## Report to the Future Melbourne Committee

**Ministerial Planning Referral: TPMR-2020-53**  
**540-550 Lonsdale Street, Melbourne**

**16 February 2021**

**PLANNING REPORT MINISTERIAL REFERRAL**

Figure 18 – Healeys Lane and Lonsdale Street

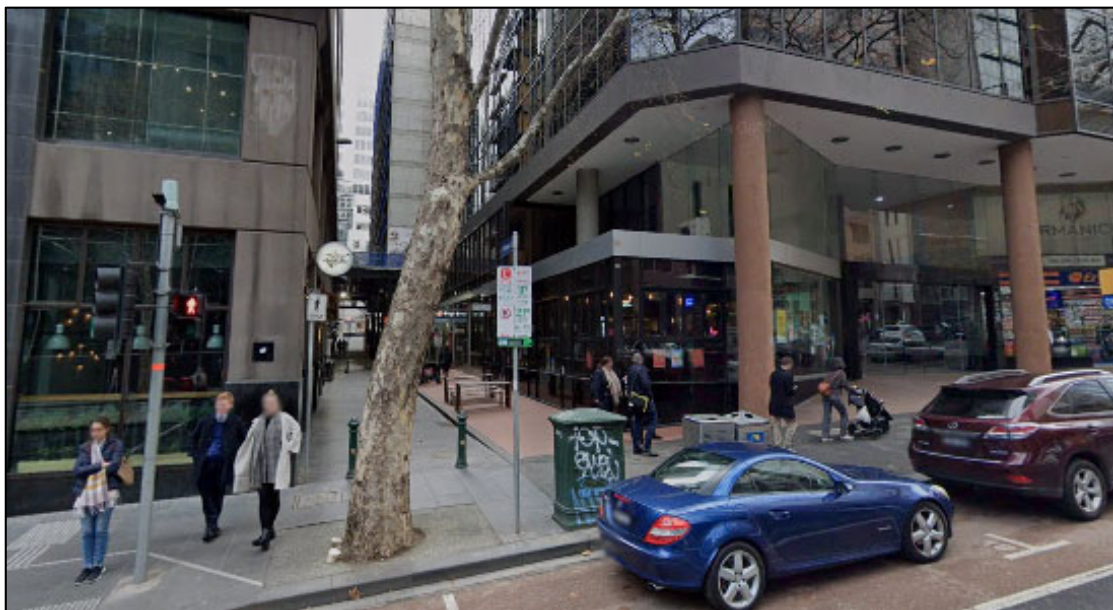
As identified by the City of Melbourne's Urban Design team, the loss of the publicly accessible space where Lonsdale Street and Little Lonsdale Street intersect with Healeys Lane is problematic. The existing conditions at this section of the Site contain a cantilevered section of the building over a pedestrian footpath at Little Lonsdale Street (Figure 17) and a building setback and publicly accessible area at Lonsdale Street (Figure 18).

- The removal of the publicly accessible open space at the intersection of Healeys Lane and Lonsdale Street (Figure 18). The loss of the publicly accessible space at Lonsdale Street is not supported as this space contributes to Healeys Lane being a desirable pedestrian thoroughfare. It should be retained with a higher quality design response integrated into the proposal. Retaining this space will combine with the above recommended setback for a pedestrian footpath to improve the public realm and enhance pedestrian movement. Further, a full length footpath / colonnade at this section of the Site will enable clear views up and down the lane which will promote use of the lane.

**Figure 19 – Proposed development including surrounding street wall height analysis**

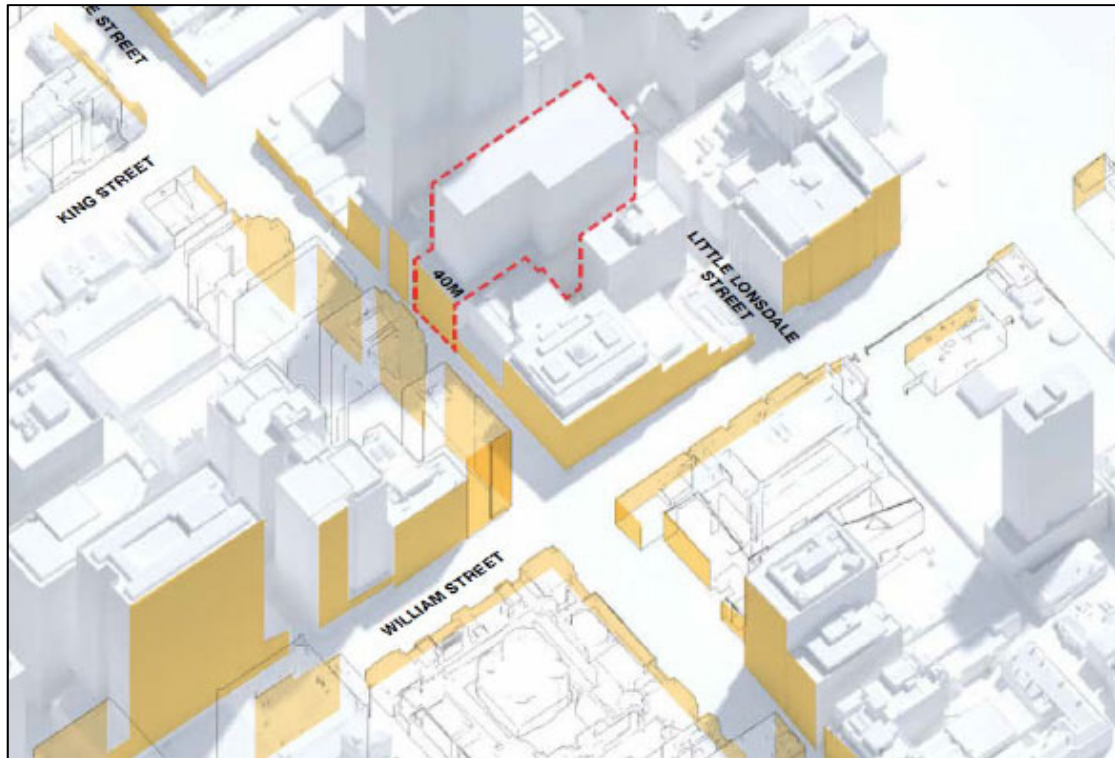
<p>The application seeks to comply with the modified requirement of 40 metres.</p> <p>The variation is acceptable for the following reasons:</p> <ul style="list-style-type: none"> <li>▪ The proposal inserts a street wall height and vertical rhythm that responds to the surrounding built form context. The height of the street wall is consistent with the street wall heights of 233 Lonsdale Street, 552 Lonsdale Street, 560 Lonsdale Street, 525 Lonsdale Street, 555 Lonsdale Street, and 565 Lonsdale Street (Figure 19 and 20).</li> <li>▪ The shadow cast by the proposed development is not unreasonable, affecting the Lonsdale Street road reserve throughout the day but not affecting any areas of public open space or parks.</li> <li>▪ The proposed street wall provides a human scale through vertical and horizontal architectural expression with a pedestrian focused ground level interface.</li> <li>▪ The 37 metre street wall height at Little Lonsdale Street provides an appropriate transition from the 52 metre height street wall of building adjoining the site to the east</li> </ul>

**Figure 21 - Built form at the south side of Little Lonsdale Street**

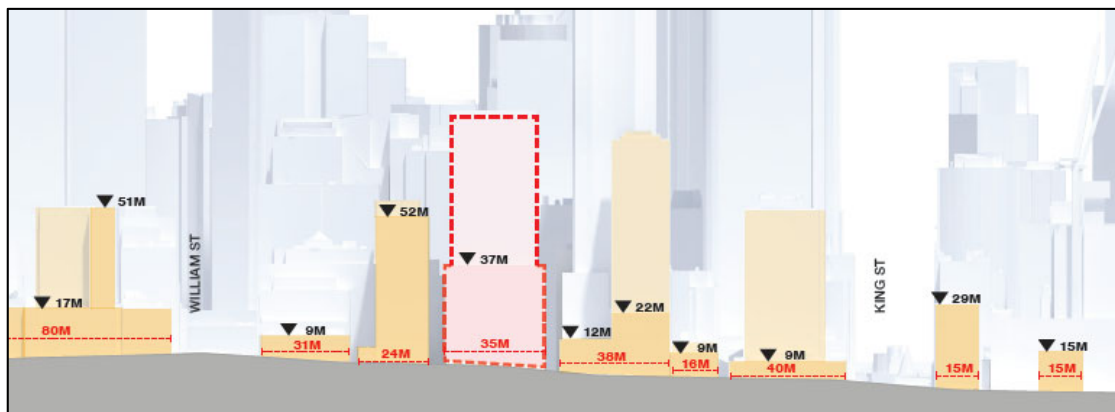
and the 12 metre street wall of the building adjoining the site to the west (Figure 21).

**Figure22 – Additional shadow cast by the proposal at 11am and 12pm on September 22**

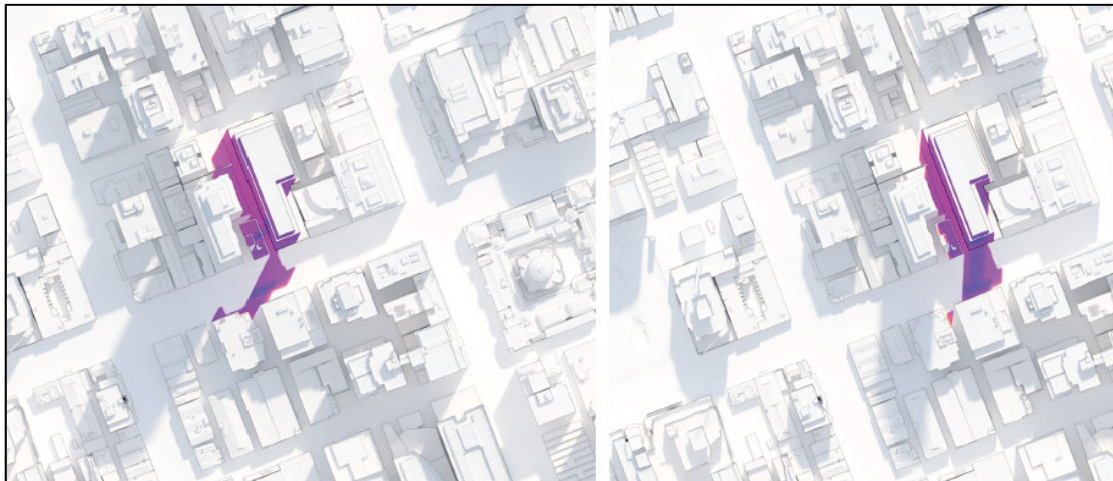
<b>Assessment</b>			
<p>The application seeks to comply with the modified requirement, setting back the tower 5 metres from the title boundary.</p> <p>The proposed modified requirement is acceptable for the following reasons:</p> <ul style="list-style-type: none"> <li>▪ The proposed shadow impacts resulting from the tower are limited to the Lonsdale Street road reserve, impacting the public realm less than the larger buildings on the same section of Lonsdale Street (Figures 22 and 23).</li> <li>▪ The proposal does not contain dwellings. Regardless, the proposed setbacks combined with the lanes either side of the Site allow for reasonable (approximately 9 metres) separation between the proposed tower and the adjoining properties, avoiding unreasonably privacy impacts and impacts to solar access. This specifically relates to 560 Lonsdale Street which contains dwellings. The remaining adjoining properties do not contain dwellings.</li> <li>▪ The setbacks and façade treatment ensure the building does not present as a continuous wall at the street level.</li> <li>▪ The proposal does not have any significant impacts to heritage buildings in the immediate surrounds.</li> </ul>

**Figure 24 – Proposed development showing setbacks**

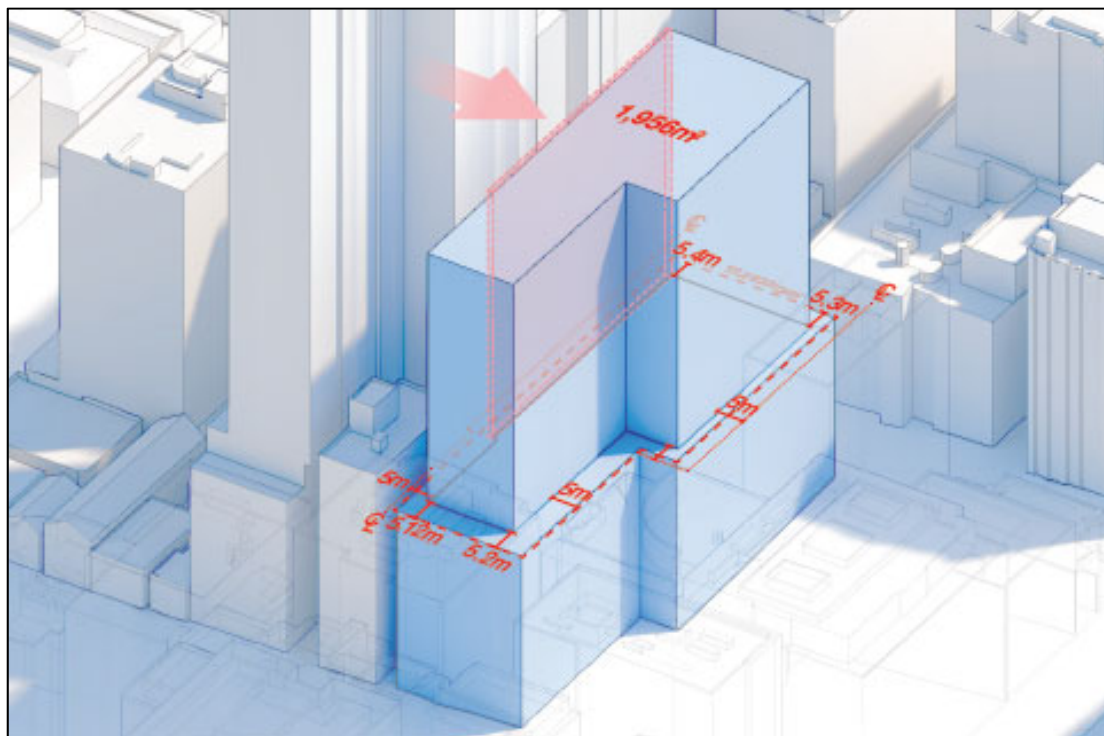
the site.	and maintain open sky views between them.
<b>Assessment</b>			
<p>The application seeks to comply with the modified requirement, which is necessary as the proposal is above 80 metres in height. Side and rear setbacks are reduced below 10% of the total height in places, but increased in others (positively to Healeys Lane) such that the overall floor plate retains the same area (Figure 26). The resulting setbacks should never be below 5.0m (excluding architectural features).</p> <p>Again, the supplied plans show the tower setback less than 5 metres due to the presence of architectural details at the east side of the north elevation (Little Lonsdale Street). The definition of a setback allows for an architectural feature of 300mm encroaching into the 5 metre requirement. The plans show architectural features resulting in the setback being 4.695 metres from the title boundary which is 5mm outside the mandatory control. This is a minor matter and can be resolved through a permit condition to limit the architectural feature.</p> <p>The proposed modified requirement is acceptable for the following reasons:</p> <ul style="list-style-type: none"> <li>▪ The proposal contains setbacks that align with the requirements, setting back the tower 5 metres from each boundary or from the centre line of the adjoining lane (provided the plans are amended to show compliance with the mandatory setback as noted above).</li> <li>▪ The setbacks have guided the floorplate area and the proposal does not seek to increase the floorplate area (Figures 24 and 25).</li> <li>▪ The proposed tower is more than 10 metres from an adjoining tower.</li> <li>▪ The proposed tower does not introduce unreasonable bulk to the public realm or impact any civic landmarks or significant open space.</li> <li>▪ The proposal does not unreasonably impact any nearby heritage place or streetscape.</li> <li>▪ The design of the proposal allows for reasonable light and air to the proposed building and to the adjoining larger scale developments.</li> </ul>
